October 13, 2010

RE: Ventura County Technical Guidance Manual Comments

Perforated Corrugated Metal Pipe Infiltration System

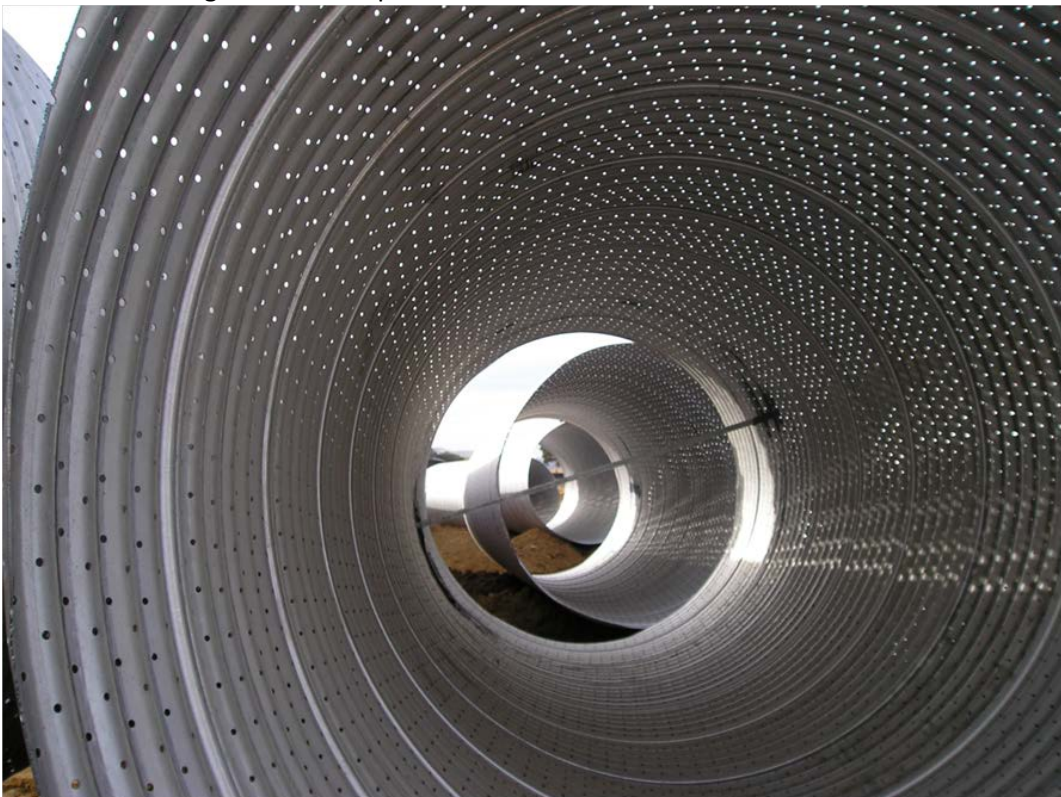
Please add Perforated Corrugated Metal Pipe (CMP) to the list of infiltration products in Table 6-15 in section INF-6. Sample CMP photos are attached to this letter. Additional product information can be found at:  
<http://www.contech-cpi.com/Products/StormwaterManagement/SubsurfaceInfiltration/CMPDetentionandInfiltrationSystem.aspx>
